ADDENDUM NO. 1

CONTRACT NO. 2012-FT-1

LARKSPUR FERRY TERMINAL SECURITY IMPROVEMENTS

ADDENDUM NO. 1
CONTRACT NO. 2012-FT-1
LARKSPUR FERRY TERMINAL SECURITY IMPROVEMENTS

SHEET TITLE
DETAILS 2

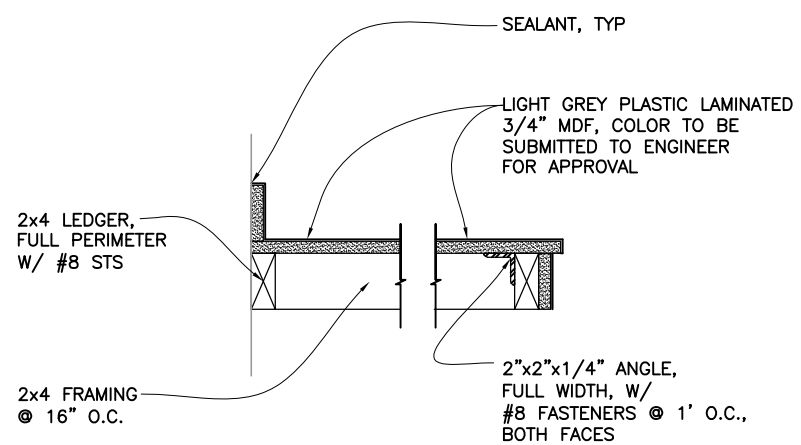
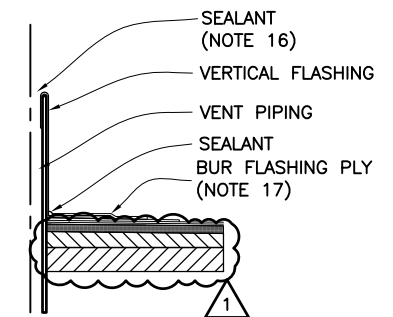
1. **REPLACE** Drawings Nos. 8 and 12 with the revised drawings attached. Revisions are “bubbled” and denoted with triangular symbols marked “1.”

3 SECTION OF ROOF EDGE WITH PIPE STAND
SCALE: 2"=1'-0" (NOTE 19)

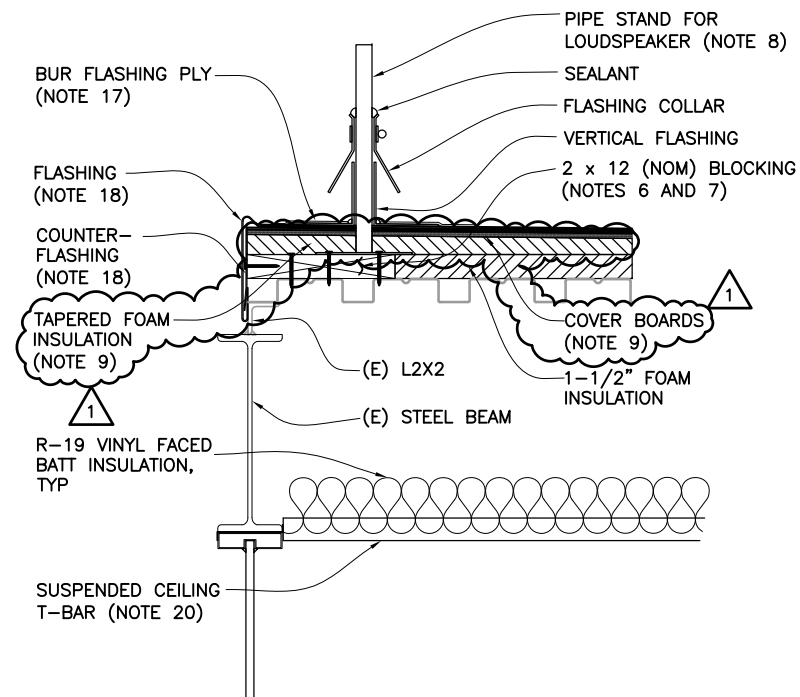
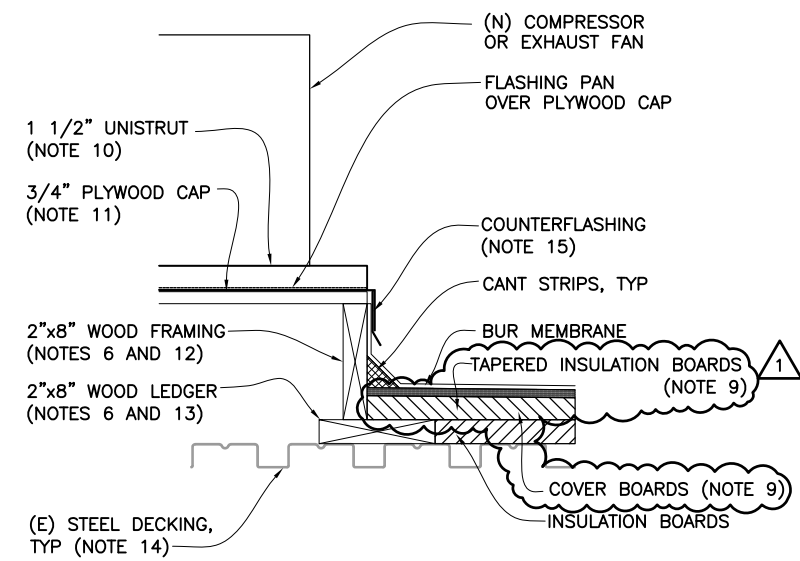
19. THE PIPE STAND DETAIL SHALL ALSO BE MODIFIED AS REQUIRED AND USED FOR THE HVAC SUPPLY DUCTING PENETRATIONS AND THE ELECTRONICS MAST PENETRATION.
20. SUSPENDED CEILING NOTES ARE SHOWN ON DRAWING NO. A9
